Subject: REAR MOUNT CAMERA DOES NOT OPERATE	Bulletin No: 09-016/13
	Last Issued: 05/07/2013

2013 CX-5 with VINs lower than JM3KE*****155008 (produced before October 7, 2012)

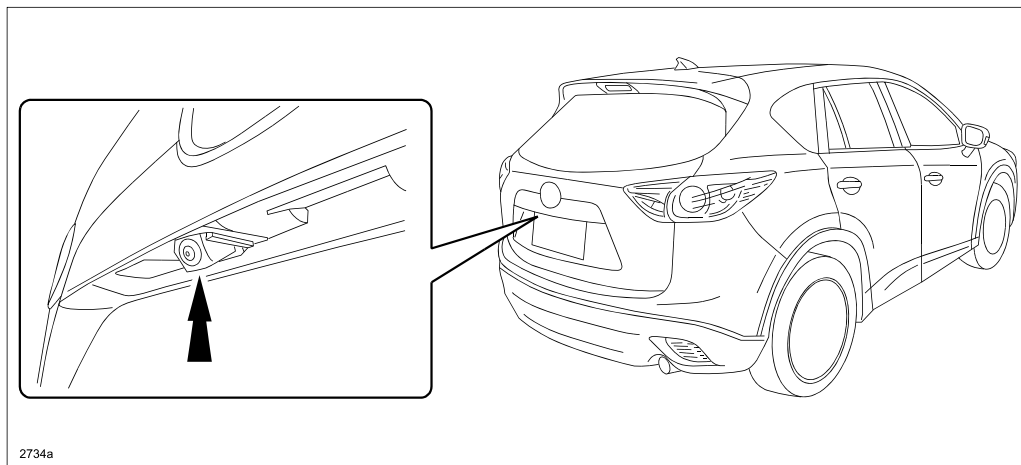
Some vehicles may exhibit an inoperative rear mount camera. This concern may be caused by water entering inside the camera during a high-pressure car wash.

The shape of the camera has been changed to eliminate this concern.

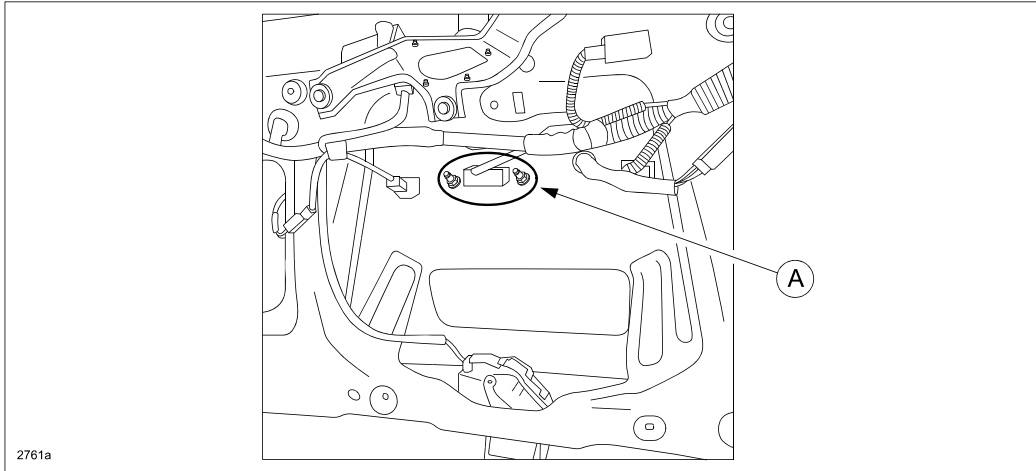
1. Verify the customer concern.
2. Inspect the rear mount camera according to the instructions on MS3 online or the Workshop Manual (section 09-20 REAR MOUNT CAMERA INSPECTION).
3. If the rear mount camera is found to be faulty, replace it with a modified one according to the instructions on MS3 online or the Workshop Manual (section 09-20 REAR MOUNT CAMERA REMOVAL/INSTALLATION).
4. Locate the opener switch connector (A).

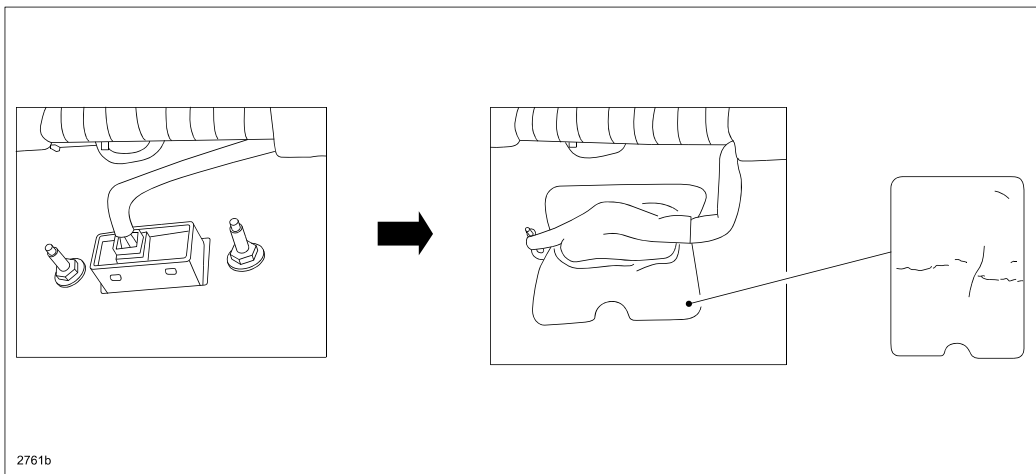
5. Attach a water-proof sheet over the opener switch connector as shown below.

NOTE: Be sure to attach a water-proof sheet, even if the vehicle did not originally have one installed.
